Access Compliance Report

Public Rights-of-Way

Intersection ID: 28085	Main Street: LANDEN_DR	Cross Street: OLD_CORRAL_ST	Location: NW
ADA ID: CBACDDD99F8C	Ramp Type: PerpDiag	Initial Pass/Fail: Fail	Overall Compliance: No
		Severity Score: 17.5

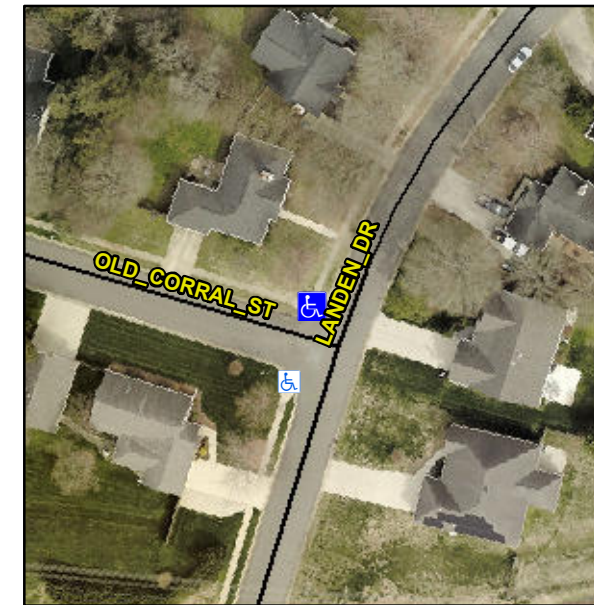
Not Found, R304.5.1

Compliance	Description	Data	Compliance	Description	Data
N/A	Ramp Length (in)	90.0	Yes	Ramp Slope (%)	6.8
No	Ramp Width (in)	35.0	Yes	Ramp XSlope (%)	1.8
N/A	Flare Type LT	N/A	N/A	Flare Type RT	N/A
N/A	Flare Slope LT (%)	N/A	N/A	Flare Slope RT (%)	N/A
N/A	Flare Traversable LT?	N/A	N/A	Flare Traversable RT?	N/A
N/A	Landing Length (in)	N/A	N/A	DWS Provided?	N/A
N/A	Landing Width (in)	N/A	N/A	DWS Contrast?	N/A
N/A	Landing Slope (%)	N/A	N/A	DWS Length (in)	N/A
N/A	Landing X Slope (%)	N/A	N/A	DWS Full Width?	N/A
N/A	Landing Curb? (Y/N)	N/A	N/A	DWS Offset (in)	N/A
N/A	Shared Landing?	N/A			
N/A	Gutter Ponding?	N/A	N/A	Gutter Slope (%)	N/A
N/A	Gutter Lip Ht (in)	0.5	N/A	Gutter X Slope (%)	N/A
N/A	Painted X Walk1?	No	N/A	Painted X Walk2?	No
	X Walk 1 Direction	To SW		X Walk 2 Direction	To SE
N/A	X Walk 1 Width (in)	N/A	N/A	X Walk 2 Width (in)	N/A
	X Walk 1 Slope (%)	1.0		X Walk 2 Slope (%)	4.7
	X Walk 1 X Slope (%)	1.6		X Walk 2 X Slope (%)	0.6

Remove & Replace Curb Ramp With Two New Directional Ramps or Equivalent.
